## **Access Compliance Report Public Rights-of-Way** (Curb Ramps)

Main Street: WHITEHALL EXECUTIVE CENTERS SDStreet: N/A Location: Intersection ID: 10041624 NW ADA ID: 5226C12A9C8C Ramp Type: PerpDiag Initial Pass/Fail: Fail **Overall Compliance: No** 35 **Severity Score:**

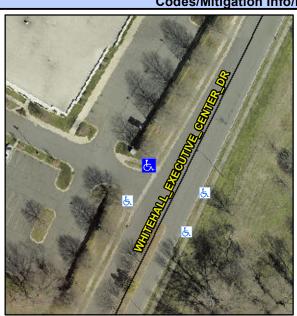
Surveyor Notes:

Not Found, R304.5.1

**ENTRANCE** Street 1 Name Stop Condition-Street 2 StopSign Street 2 Name ALL EXECUTIVE CENTER DR Remove & Replace Curb Ramp With Two New Directional Ramps or Equivalent.

Possible Solutions:
